Access Compliance Report

Public Rights-of-Way

Intersection ID: 10028048	Main Street: HARTFORD_AV	Cross Street: N/A	Location: SE
ADA ID: E6EE7DA96237	Ramp Type: ParaDiag	Initial Pass/Fail: Fail	Overall Compliance: No
Codes/Mitigation Info/Possible Solution		Field Measurements/Component Compliance	
Severity Score: 26.25

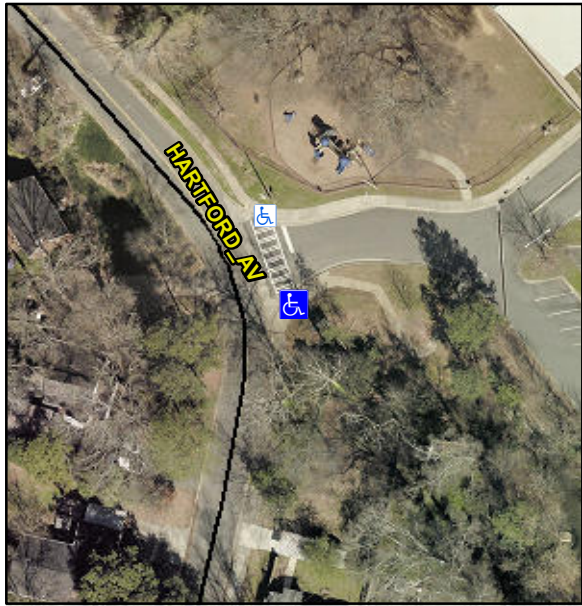
RT RP < 5%

R304.3.2, R304.5.3

Compliance	Description	Data	Compliance	Description	Data
N/A	Ramp Length LT (in)	65.0	N/A	Ramp Length RT (in)	47.0
Yes	Ramp Width LT (in)	82.0	Yes	Ramp Width RT (in)	82.0
No	Ramp Slope LT (%)	13.2	Yes	Ramp Slope RT (%)	1.4
Yes	Ramp XSlope LT (%)	0.8	No	Ramp XSlope RT (%)	2.9
N/A	Landing Length (in)	N/A	N/A	DWS Provided?	N/A
N/A	Landing Width (in)	N/A	N/A	DWS Contrast?	N/A
N/A	Landing Slope (%)	N/A	N/A	DWS Length (in)	N/A
N/A	Landing X Slope (%)	N/A	N/A	DWS Full Width?	N/A
N/A	Landing Curb? (Y/N)	N/A	N/A	DWS Offset (in)	N/A
N/A	Shared Landing?	N/A			
N/A	Gutter Ponding?	N/A	N/A	Gutter Slope (%)	N/A
N/A	Gutter Lip Ht (in)	1.0	N/A	Gutter X Slope (%)	N/A
N/A	Painted X Walk1?	Yes	N/A	Painted X Walk2?	No
	X Walk 1 Direction	To N		X Walk 2 Direction	To W
N/A	X Walk 1 Width (in)	110.0	N/A	X Walk 2 Width (in)	N/A
	X Walk 1 Slope (%)	2.1		X Walk 2 Slope (%)	6.2
	X Walk 1 X Slope (%)	7.1		X Walk 2 X Slope (%)	2.6
N/A	Ramp inside XWalk1?	Yes	N/A	Ramp inside XWalk2?	N/A

Remove & Replace Curb Ramp With Two New Directional Ramps or Equivalent.
